**CONWAY**  
HISTORIC DISTRICT COMMISSION  
STAFF REPORT

**5:30pm • March 26, 2018 • City Hall**

**C1 DUPLEX REMODEL - 825/827 FAULKNER STREET**

# D1 NEW CARPORT & BACK PORCH - 537/539 OLIVER STREET

**Site Plan with Proposed Modifications**

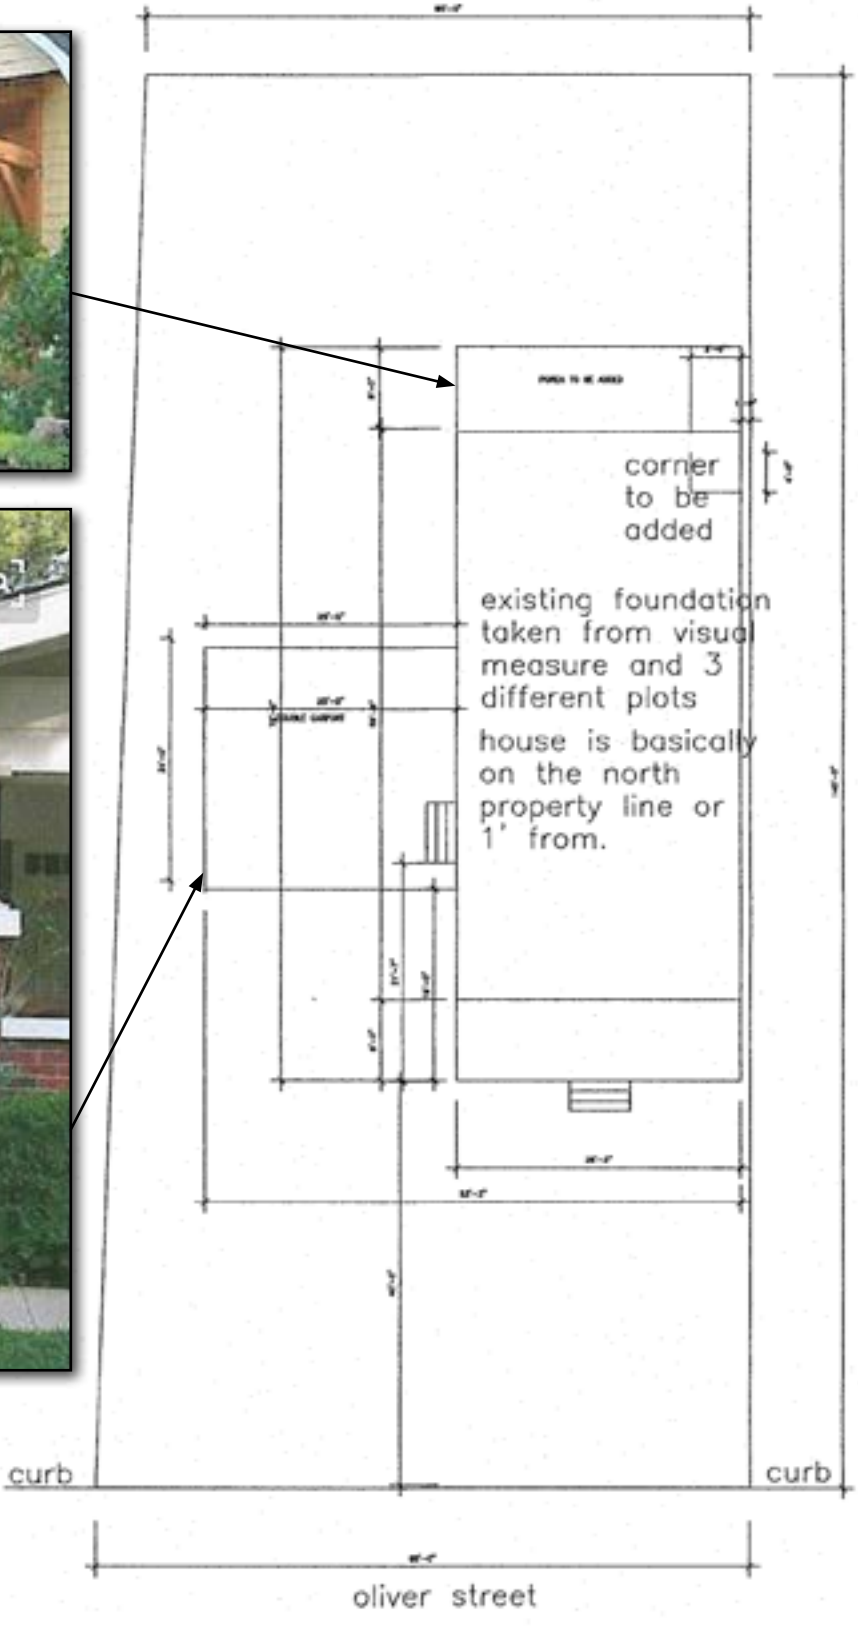
**Driveway/Parking/Carport.** There is an existing gravel parking area in front of the residence. Plans do not show a driveway. It is assumed that a new driveway and parking area will be constructed as part of the new carport area. The applicant can provide additional details at the meeting.

**Sidewalks.** There is a sidewalk along Oliver in front on the residence. It is partially destroyed. The broken area will need to be repaired.

1. The carport shall be constructed as shown in submitted plans with columns matching the existing residence.
2. Driveway - materials?
3. The broken portion of sidewalk along Oliver Street shall be replaced.
4. Doors and windows - Reuse of existing doors and windows are encouraged. Wide window and door trim matching existing traditional wide moldings shall be used.
5. The rear porch shall be allowed as proposed in a cedar "timber frame" style.

Elevations

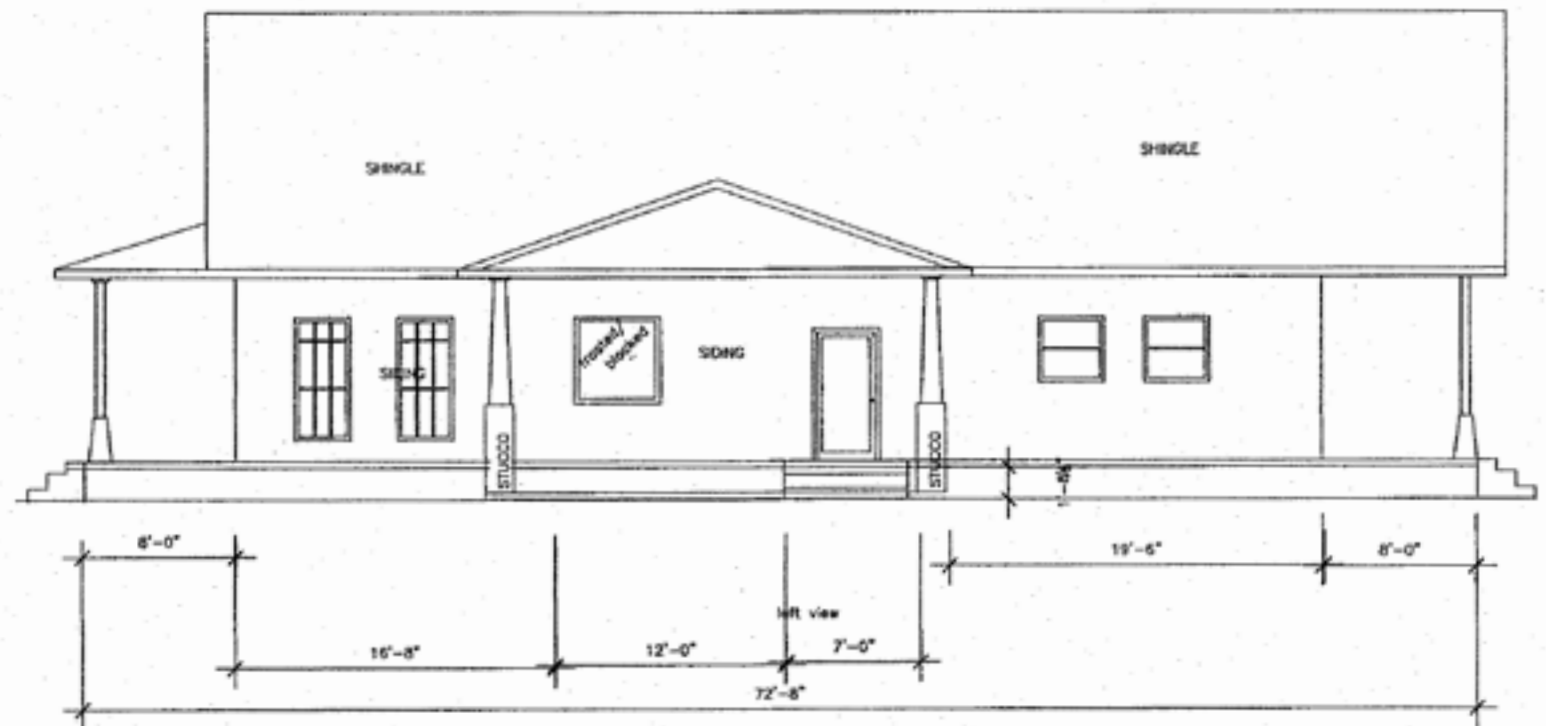
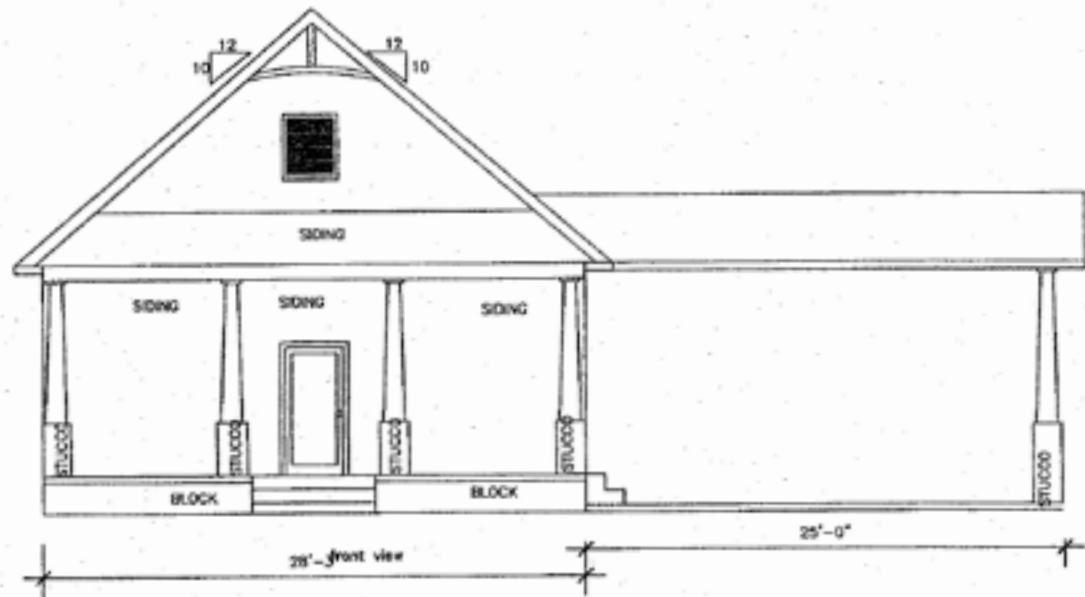
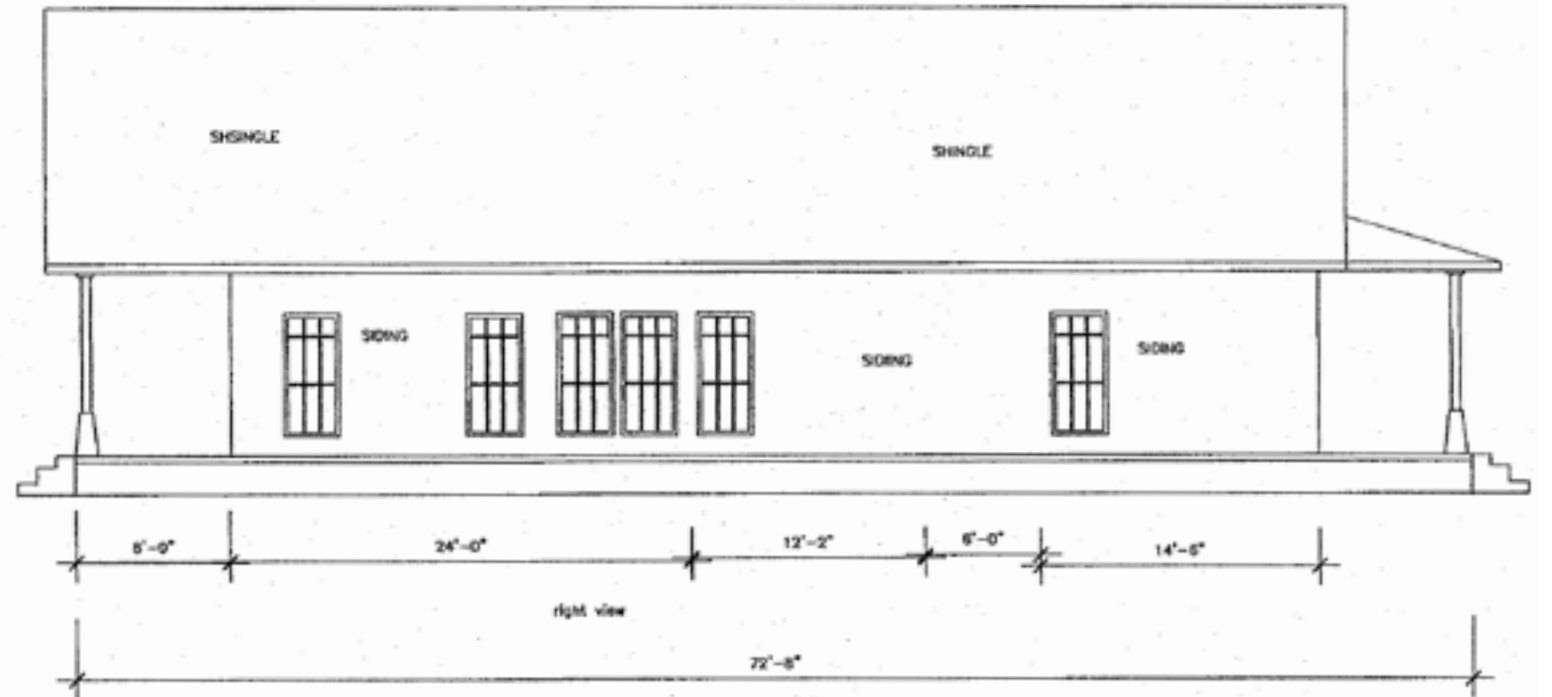
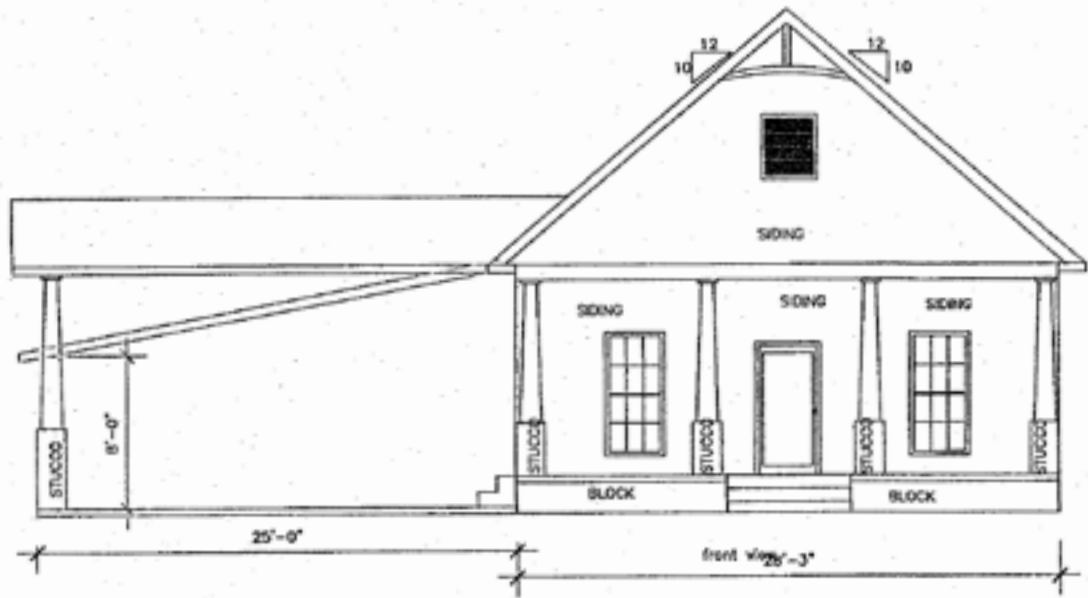
**Scale.** The size of new construction in relation to neighboring structures and the proportion of structures to the human scale. The 2 car carport larger than the majority of single car carports typically seen in the Old Conway area. However, there are several 2 car carports within the immediate area. The size and height of the primary residence can fit with the proposed 2 car carport. The carport is also recessed around 1/2 the depth of the residence.

**Height.** The average height of area structure's eaves and cornices. Also, the first floor elevation / height relationship. structures. The height of the residence will not change. The carport will continue the residence's eave height.

**Entries, Porches, and Porticos.** Appropriate entry points should be provided. Porches should be a minimum of 6 feet in depth. A 28 foot wide by 6 foot deep rear porch is proposed. This porch is unseen from the public view. A cedar timber frame style porch is proposed.

**Architectural Details, Siding, and Bricks.** Eaves, brackets, dentils, cornices, molding, columns, trim, etc. Architectural detail proposed on a new residential structures should be compatible with existing elements, in style, material, size, and shape. The carport will match the same level of detailing. Carport columns matching the existing residence are proposed.

**SITE PLAN**

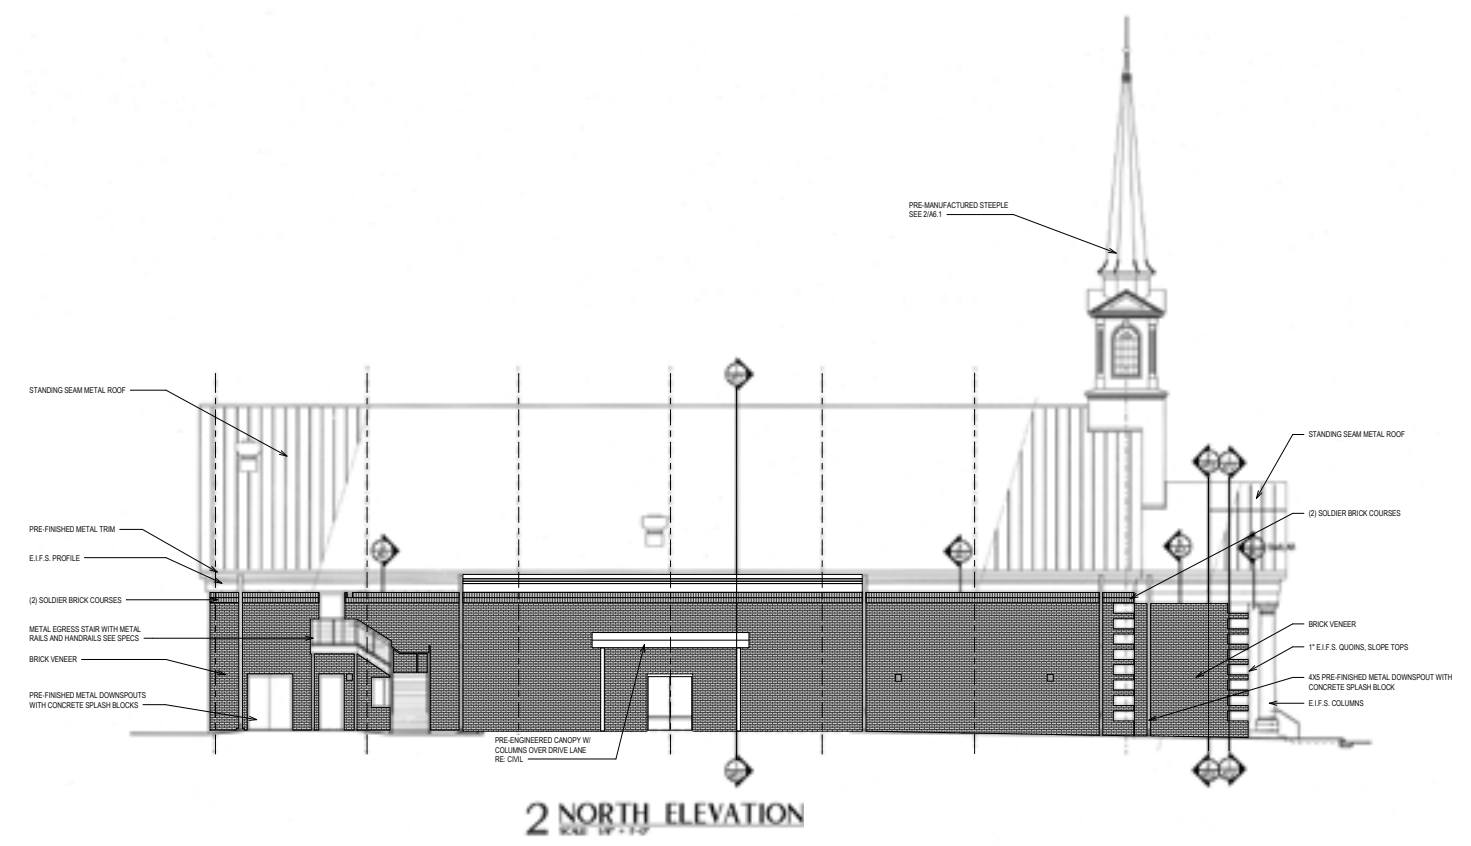
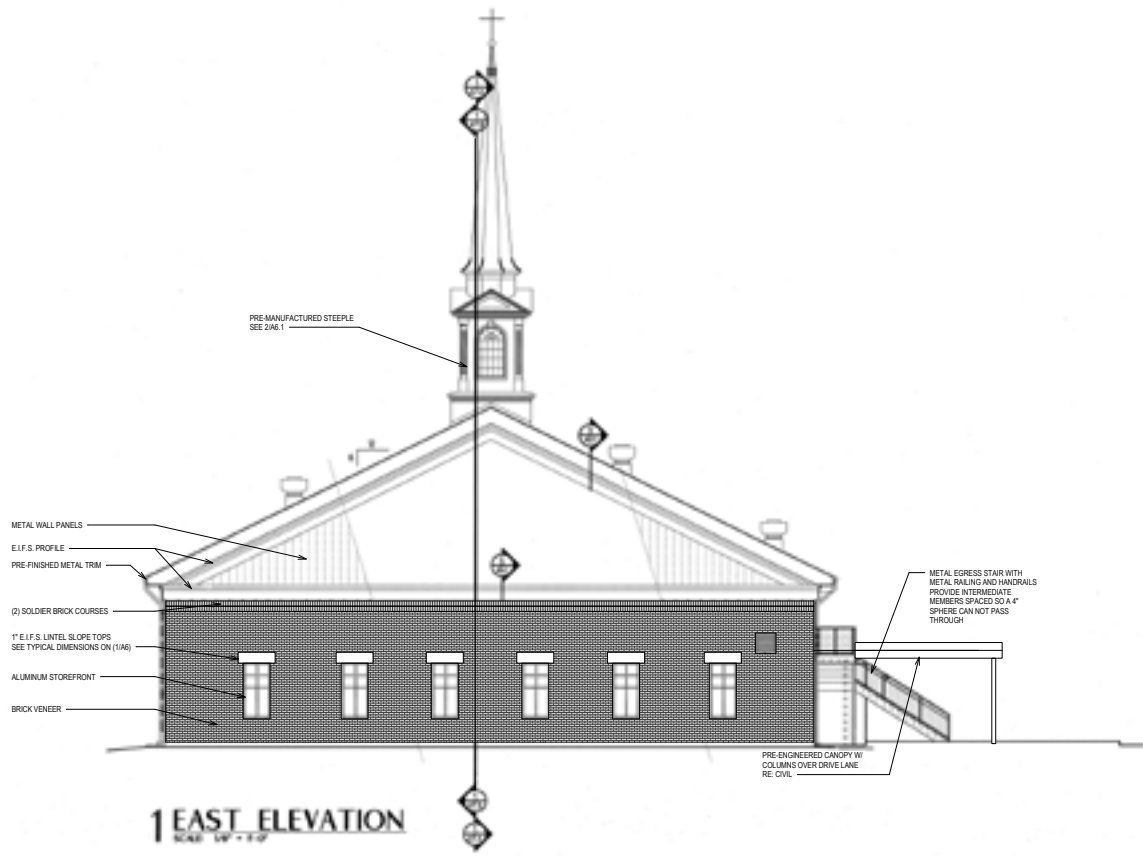
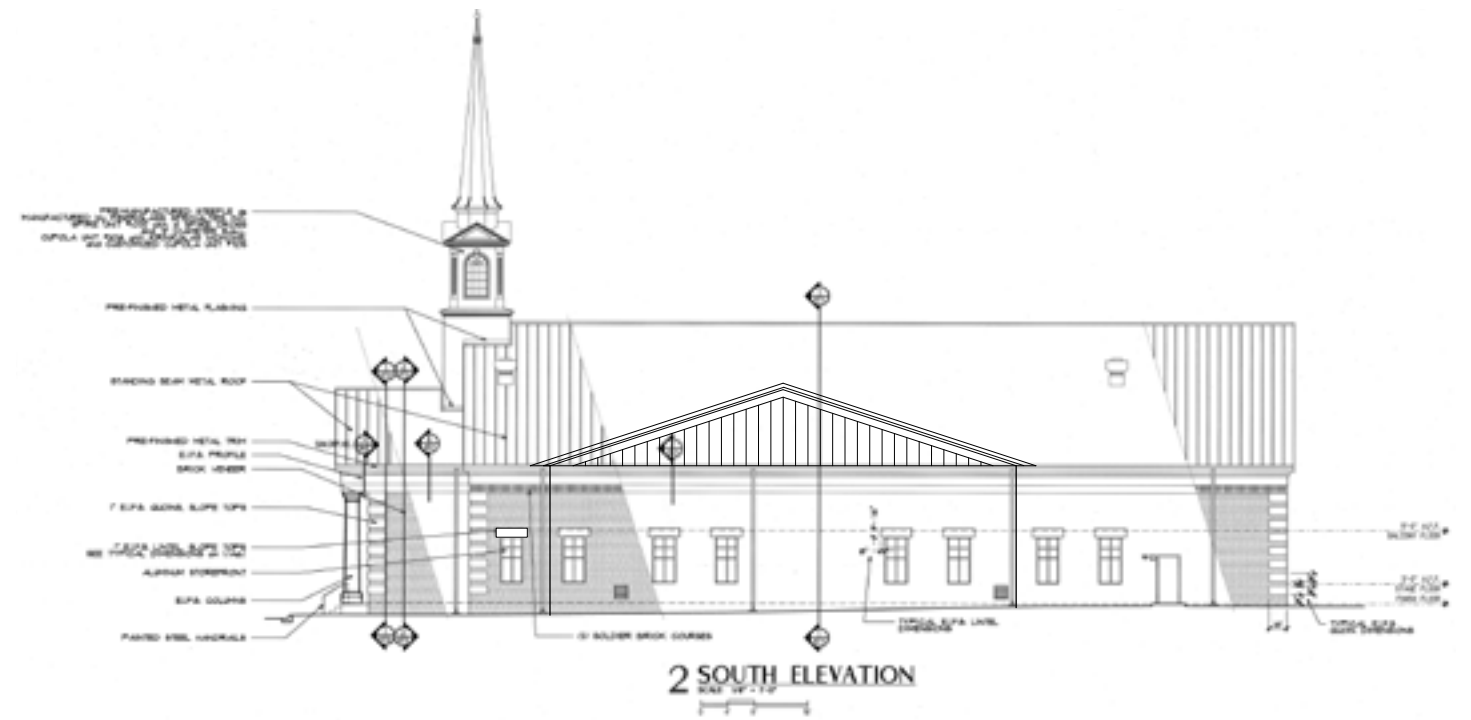
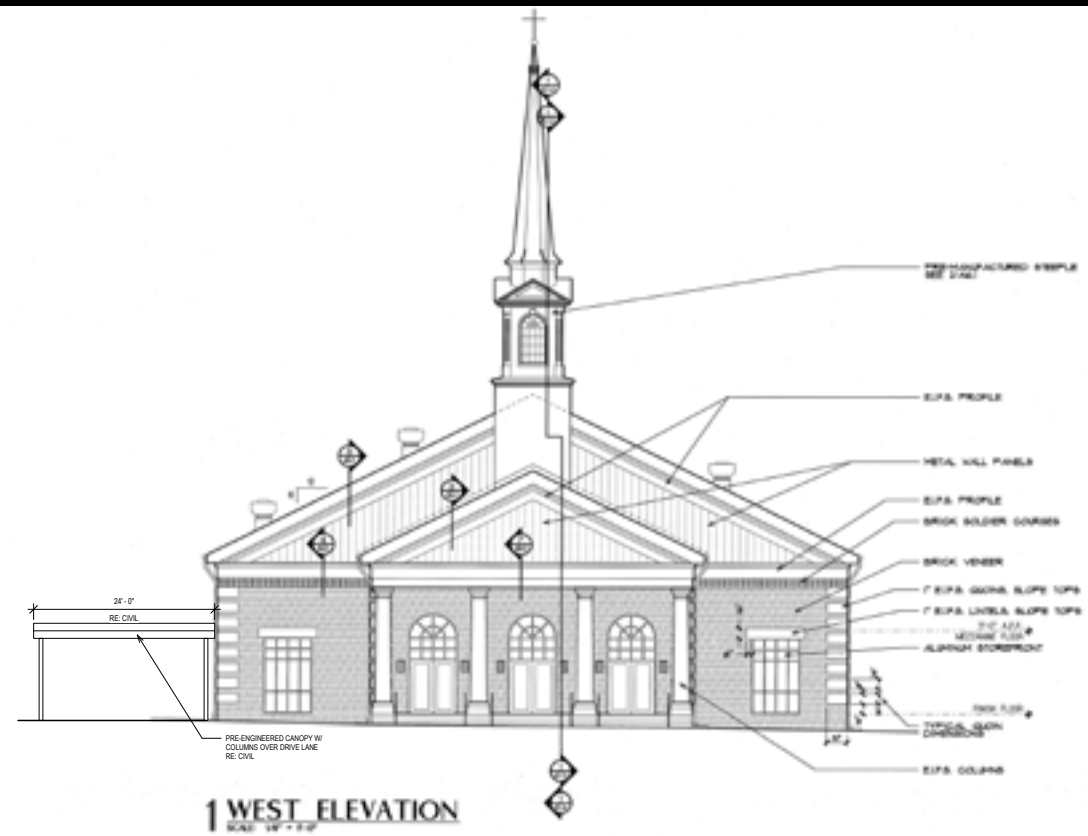
**Alley.** There are no alleys in the proposed block of construction. Clayton Street is partially closed. The south half of Clayton Street was closed in January 2011 as suggested by the Northeast Old Conway Design Overlay Plan. The Church plans to access an internal circulation drive from the remaining portion of Clayton Street.

**Driveway/Parking/Carport.** In the Old Conway Urban Zone, parking is ideally located at the rear or side of the structure. There is an existing parking lot immediately in front of the existing sanctuary. Three additional parking lots are proposed; a one behind the new sanctuary, one at the southwest corner of Sutton and Spruce, and behind the existing duplex immediately north of the new sanctuary location. These parking lots are typical asphalt paved, curbed, and guttered. Development review landscaping guidelines have been followed and are shown in the landscaping plan. Low brick walls would be appropriate to screen the entrances to the parking lots accessed from Pine and Spruce Streets.

**Sidewalks.** The OCDOD Ordinance requires that sidewalks be constructed or repaired as part of new construction. New sidewalks should be constructed along all street frontages. A wide, 8 foot sidewalk with tree wells is shown along Pine Street. Typical 5 foot sidewalks are shown along Sutton and Spruce Streets. Power poles, drop inlets, and other complications will need to be considered for proper sidewalk location. Exact locations can be further reviewed during Planning Staff development review.

**Tree preservation.** There are 2-3 substantial existing trees at the rear of the Church-owned duplex. The proposed parking lot would require removal of these trees. New canopy and understory trees will be planted as shown on the site plan and will help remediate the removal of these trees.

1. The Church building and parking lots shall be constructed as shown on submitted plans.
2. The setbacks shall be allowed as shown on the submitted site plan.

3. Sidewalks shall be constructed as shown. Exact sidewalk locations and sizes shall be determined as part of Planning Staff development review.
4. Trees and landscaping shall be planted as indicated on the site plan. Trees are to be 2” caliper at time of planting. Additional trees and shrubs may be required by Planning Staff as part of planning development review. Significant trees at the rear of the duplex may be removed.
